**SEQUOYAH NUCLEAR PLANT (SQN) - REVISIONS TO THE TECHNICAL
REQUIREMENTS MANUAL (TRM) (REVISIONS 21, 22, 23, 24, 25, 26,
AND 27) AND TECHNICAL SPECIFICATION (TS) BASES (UNIT 1
REVISIONS 22, 23, AND 24; UNIT 2 REVISIONS 22 AND 23)**

**SEQUOYAH NUCLEAR PLANT (SQN)
REVISED TECHNICAL REQUIREMENTS MANUAL (TRM)
AND TECHNICAL SPECIFICATION (TS) PAGES**

TRM FIGURE 3.1.2.6 (Units 1 & 2)
BORIC ACID TANK LIMITS
BASED ON RWST BORON CONCENTRATION

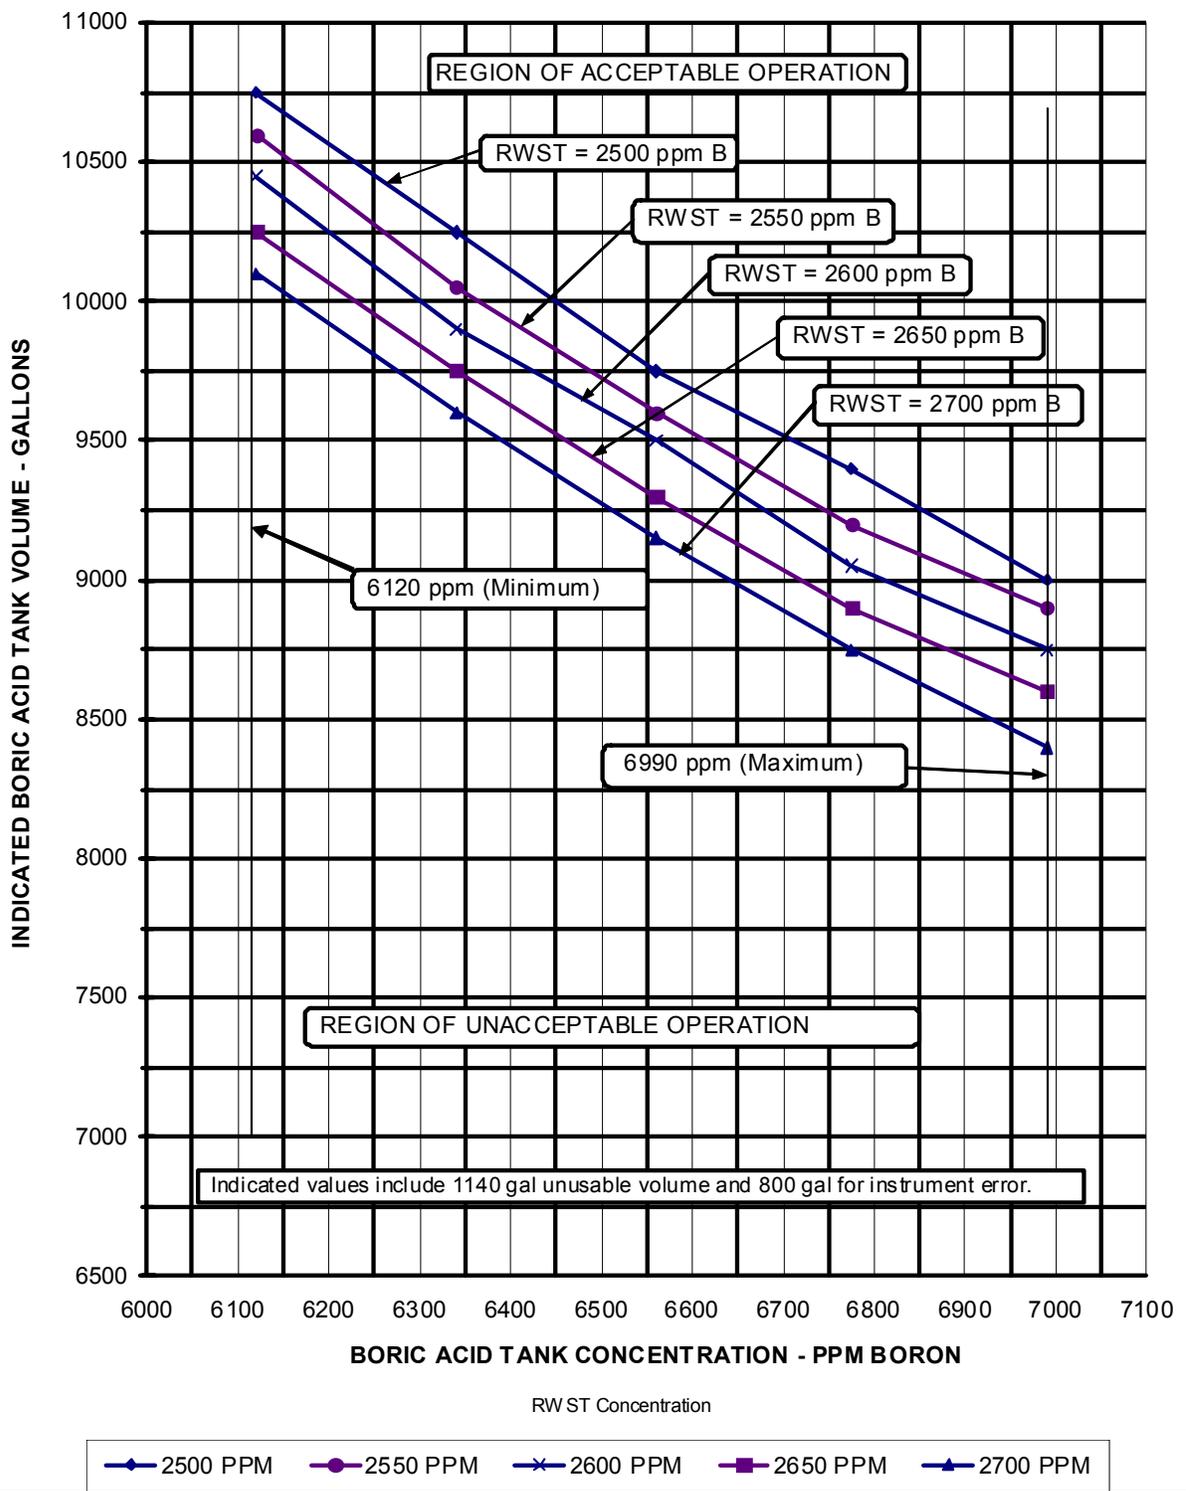
TRM Revisions 26 and 27 incorporated two different stages of a modification to correct boric acid tank level instrumentation scaling. The previous scaling did not properly take into account unusable volume at the bottom of the tank along with corrected instrument error factors. The new curve for acceptable boric acid tank concentration and volume has been incorporated for each tank by these TRM revisions.
